Addenda
For
**Prospect Maintenance Depot – Repair/Replace Metal Railings, Beams & Columns
and Painting**

Procurement No.: **2023-009Q-MPW**

Addenda No. **0004**

**Addenda Type: Repairs to Column Caps (Saddles) Revised Important Date,
Question and Answer**

COLUMN CAP REPLACEMENT DETAIL

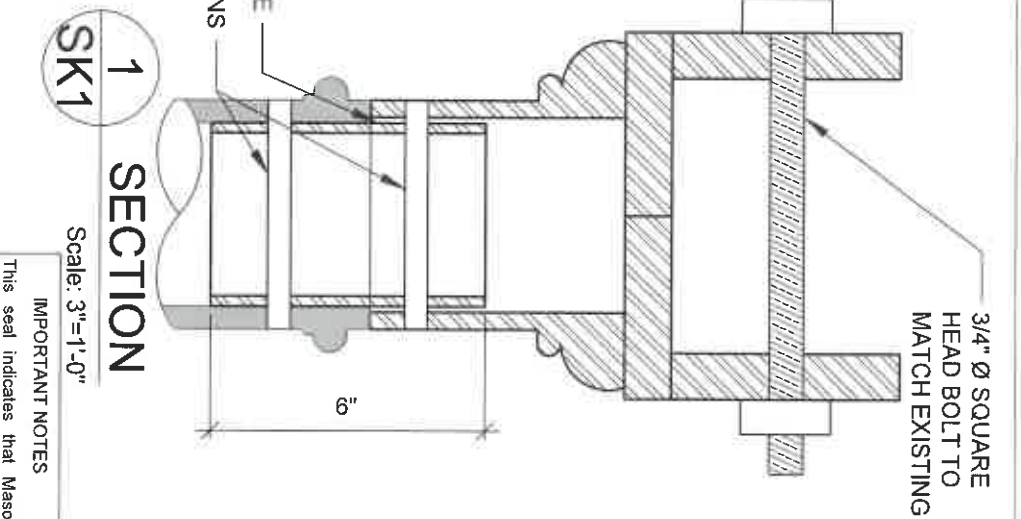
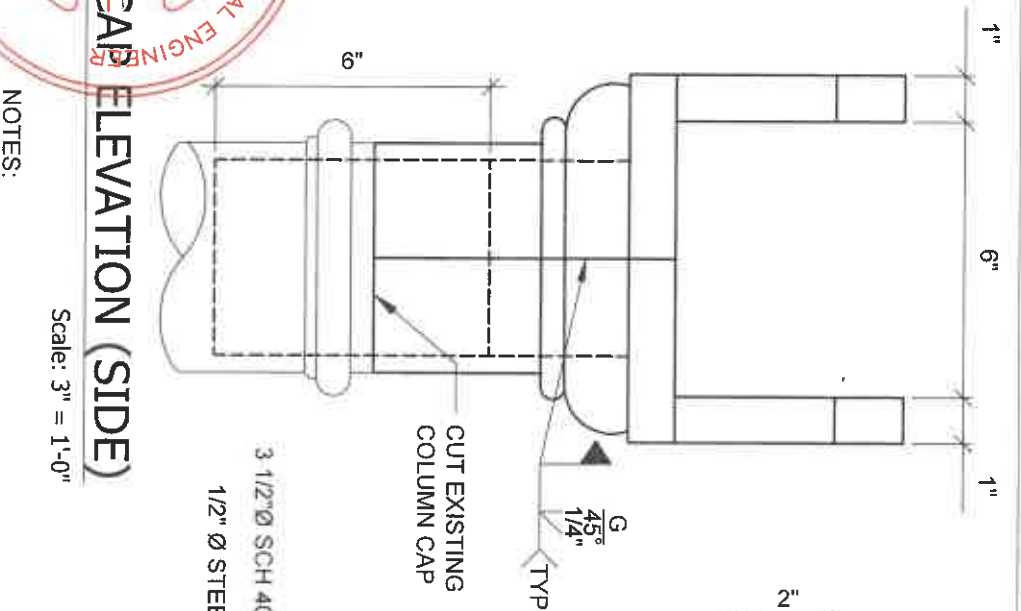
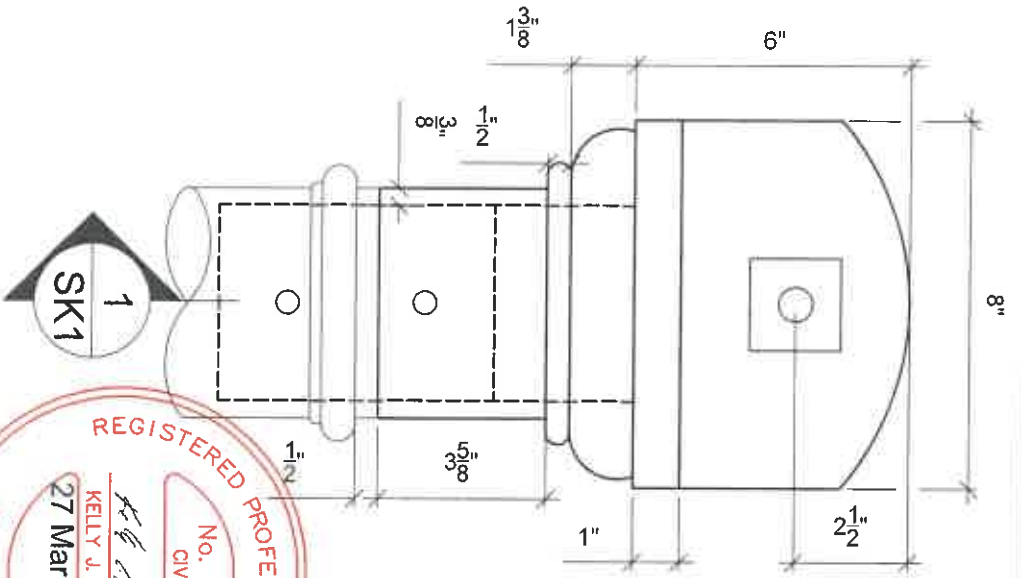
- 1. The Submission Deadline is extended to April 12, 2024, 3:00 PM Local Time.**
- 2. Attached is drawing for Balcony Repairs**

- NOTES:
1. BEAM TO BE ADEQUATELY SUPPORTED AND EXISTING CAP TO BE CUT.
 2. CAP TO BE FABRICATED IN TWO HALFS AND FITTED INTO PLACE.
 3. ORNAMENTAL DETAILS AND THICKNESS OF EXISTING COLUMN TO BE VERIFIED ON SITE.
 4. CORNER CAPS TO BE REPLACED IN SIMILAR MANNER.
